To: Mcconnell, DAVE P
Subject: RE: S-76D Exhaust duct doubler - riveted installation

Case Number: C0100507
Customer: Thai Aviation Services Limited
Aircraft S/N: 761000
Aircraft Model: S-76D
ATA: 78
Part Number: 76308-77003 / 76308-77004
Part Description: EXHAUST ASSY LHS
Case Subject: Exhaust Duct Flange Doubler-Riveted Installation ILO Welding

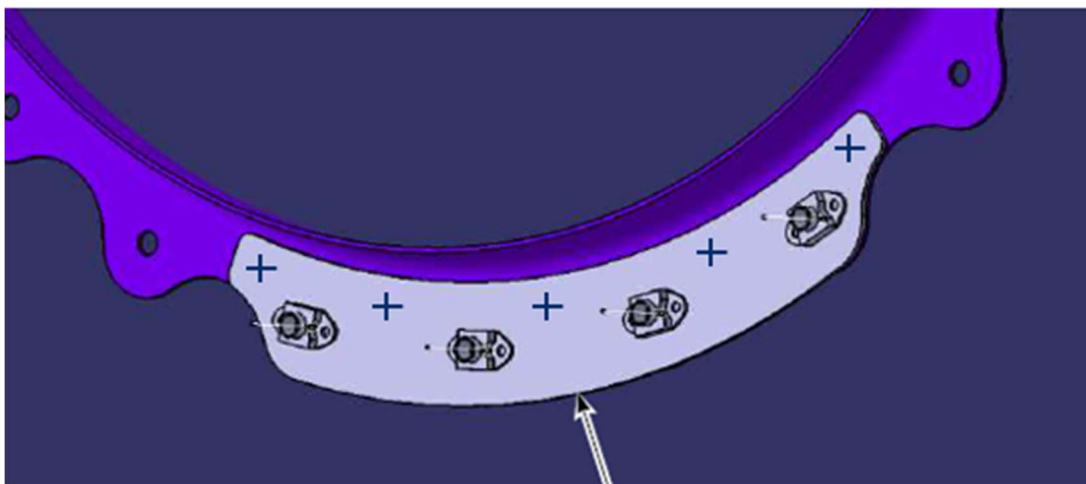
TAS has reported several instances of P/N 76308-77003 and 76308-77004 post CSN 76-262 exhaust ducts developing an out-of-round condition after incorporation of welded flange doublers per AMM Subtask 78-10-01-020-003.

The out-of-round condition makes the duct unserviceable and is contributing to ongoing AOGs on two A/C.

A Deviation to Subtask 78-10-01-020-003 is permitted to allow riveted installation of the repair doubler instead of the specified welded installation.

- 1) Disregard Task references pertinent only to welding.
- 2) Fabricate the doubler per existing Task instructions.
- 3) Attach the doubler to the exhaust duct flange at the existing nutplate fastener holes using fastener P/N CCR264CS-3-XX, or equivalent, with length appropriate to the combined flange and doubler thickness. Install new P/N MS21076-3N nutplates as required.
- 4) Add additional field fasteners as shown. Fasteners are to be of a heat resistant material spec. Diameter should be 0.125 in. minimum. EoM
